APPENDIX E: SOLE SOURCE AQUIFER SCREENING

New York Governor’s Office of Storm Recovery
Village of Patchogue Out-of-District Sewer Extension
Daniel Greene, Certifying Environmental Officer
June 4, 2015

**Re: Sole Source Aquifer Analysis – CDBG-DR Funding Application
Village of Patchogue Out-of-District Sewer Extension (Village of Patchogue, Suffolk County, NY)**

**GOSR - Patchogue River Sewer Area
 and 1/2 Mile Buffer**

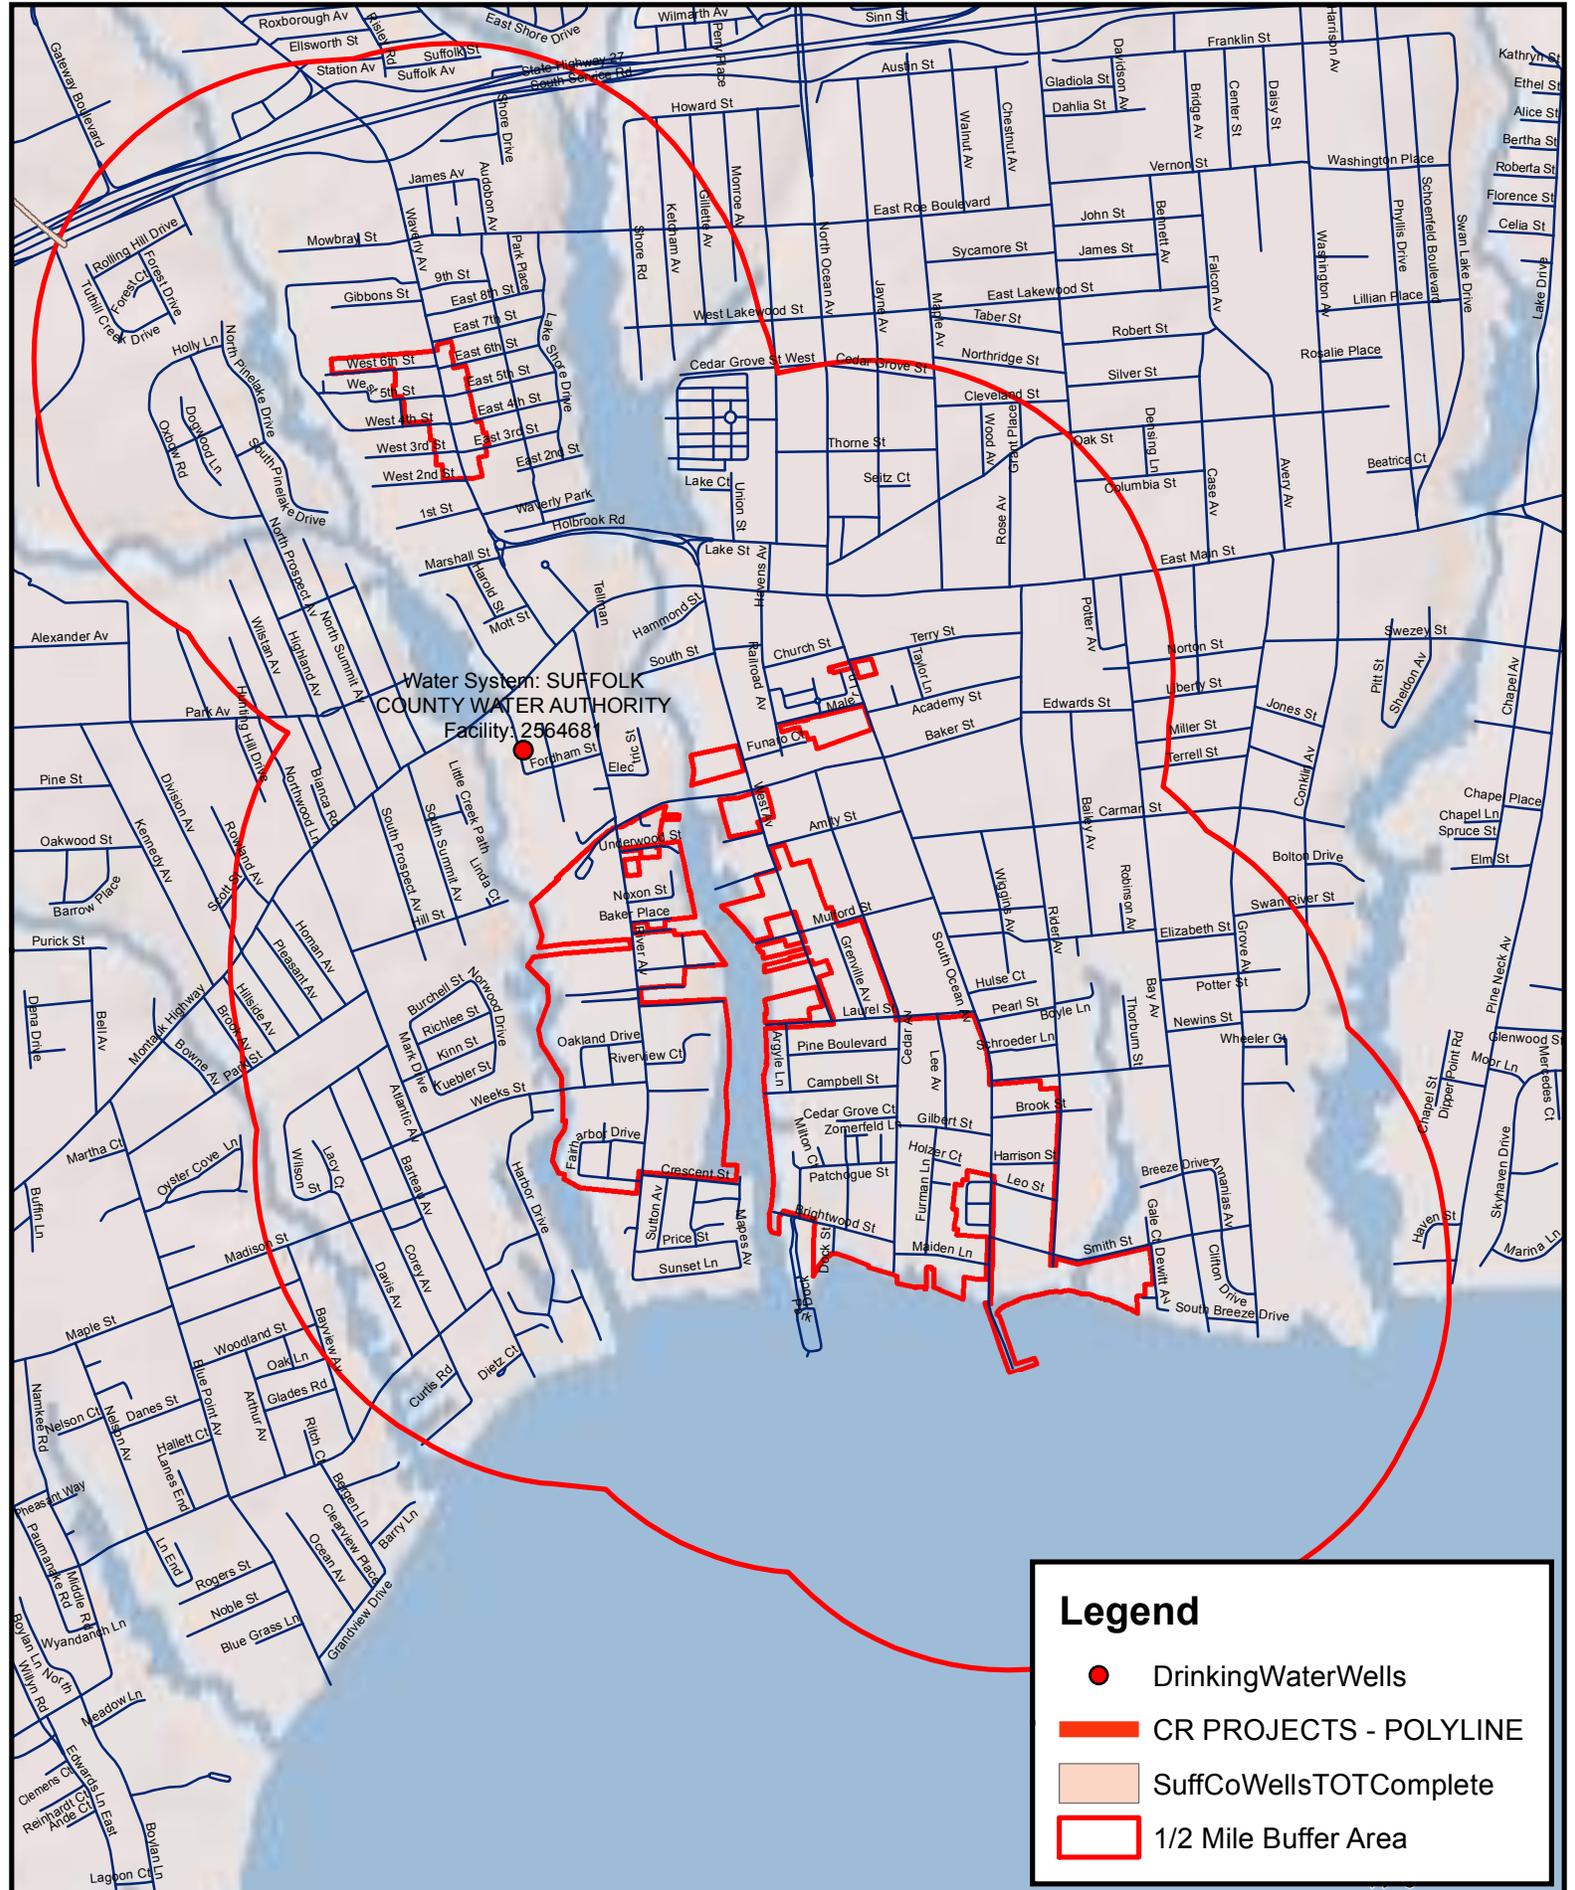
5. Provide the location of nearby existing or proposed public water supply wells or wellfields within a one half mile radius (2,640 feet) of the project/activity. Provide the name of the supplier(s) of those wells or wellfields. This information should be available from the local health department, State health department or the State environmental agency.

The proposed project is located within one half-mile radius of a public drinking water well known as "Suffolk County Water Authority Facility 2564681."

See **Figure 3**. GOSR – Patchogue River Sewer Area and ½ Mile Buffer.
